ADDENDUM NO. 3

Jesse Brown VA Medical Center

Replace Switchgear, Building 21
VA #537-14-110

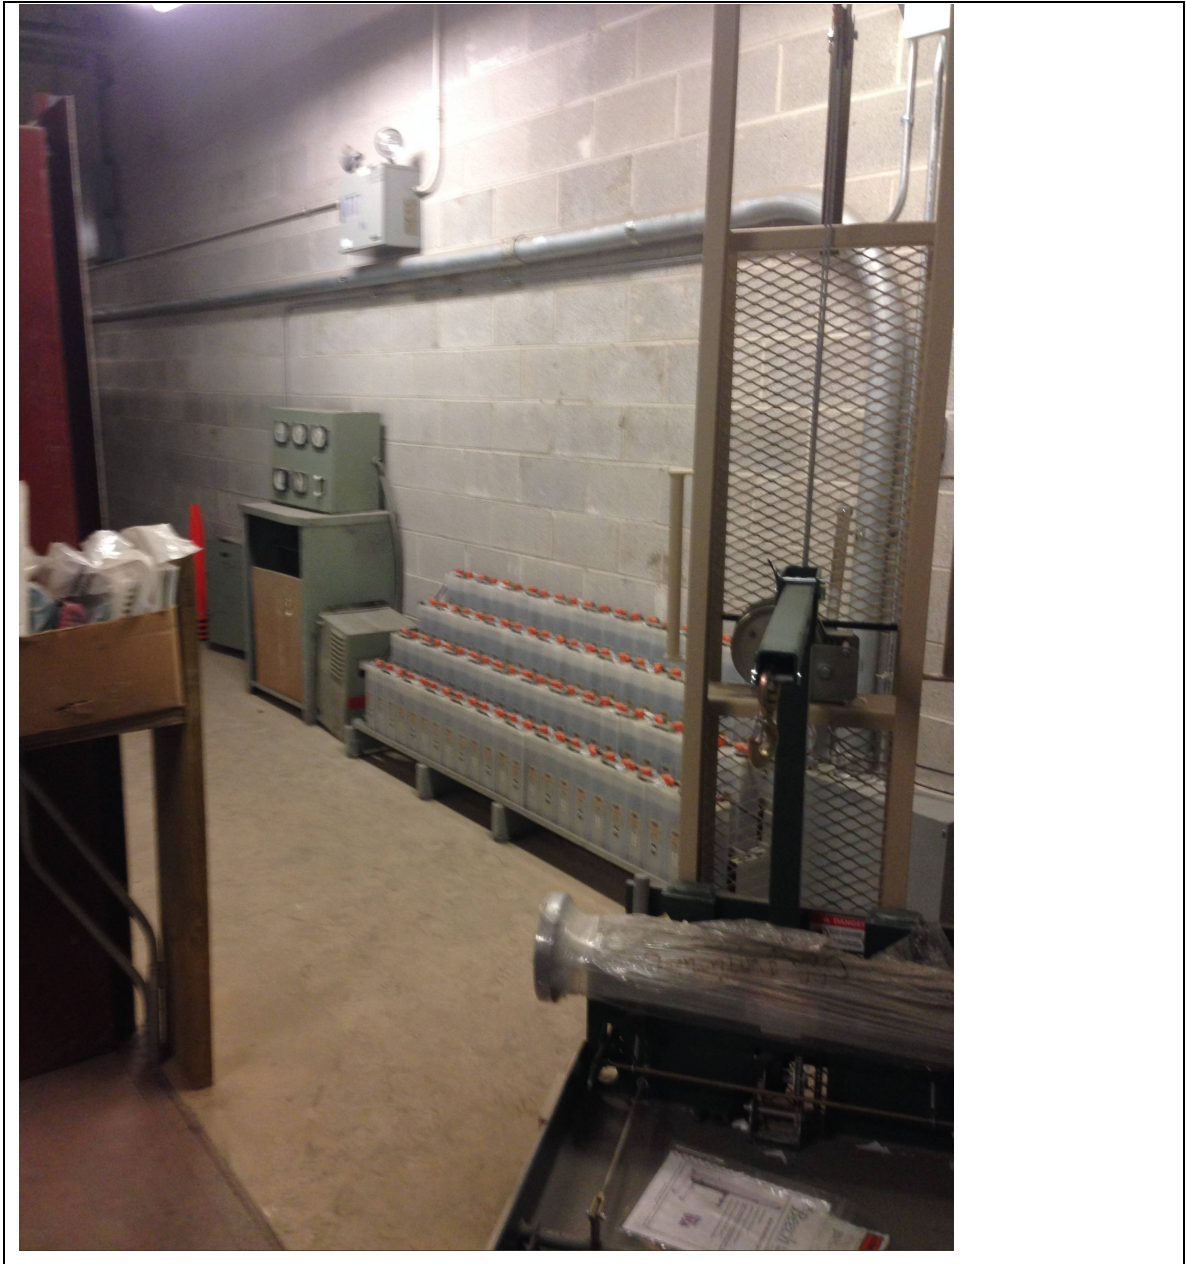
3. **Question:** Drawing 15 of 16 #537-21-ER-200- Part 1 Action Item 4.7.1: Please provide battery info (size and manufacturer) for replacement of same.

a. **Reply:** There is no record documentation available for the existing battery system and existing battery charger. The following is a photo of the existing condition.
